## **VIDMER PLAZA SUBDIVISION, AMENDED PLAT**

APPLICATION NUMBER 15 DATE August 21, 2003  
APPLICANT Vidmer Plaza Subdivision, Amended Plat  
REQUEST Subdivision

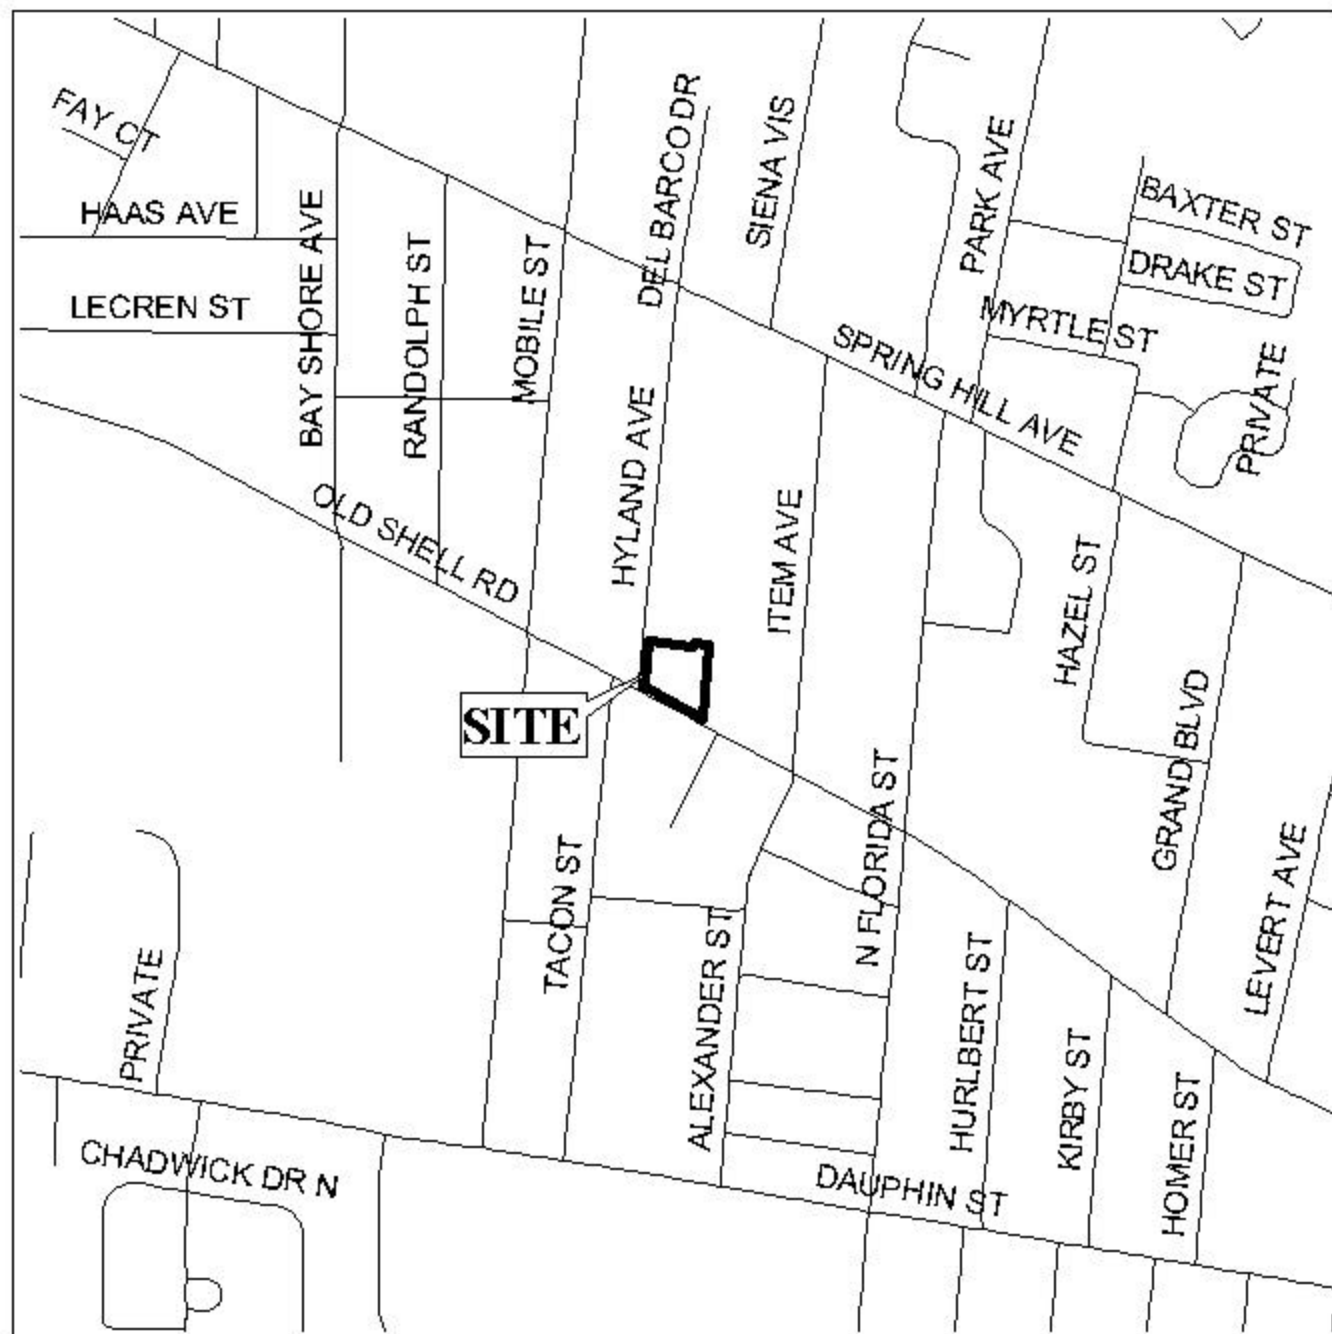
Engineering Comments: Must comply with all stormwater and flood control ordinances. Any work performed in the right-of-way will require a right-of-way permit.

Traffic Engineering Comments: Driveway numbers, size, location and design to be approved by Traffic Engineering and conform to AASHTO standards.

The purpose of this application is to remove a condition from a previous application denying direct access to Hyland Avenue. Planning Approval and PUD approval, which are site plan specific, were granted to the site; however, the proposed development for the site has changed thus the request for the removal of the condition. It should be noted that removal of this condition from the subdivision would not delete the curb cut restriction of the Planning Approval and PUD if the applicant chooses to act on those approvals.

As a means of access management, a note should be placed on the final plat stating that Lot 1 is limited to one curb cut to Hyland Avenue and one curb cut to Old Shell Road, with the size, location and design to be approved by Traffic Engineering.

The plat meets the minimum requirements of the Subdivision Regulations and is recommended for Tentative Approval subject to the following conditions: 1) the placement of a note on the final plat stating that Lot 1 is limited to one curb cut to Hyland Avenue and one curb cut to Old Shell Road, with the size, location and design to be approved by Traffic Engineering.
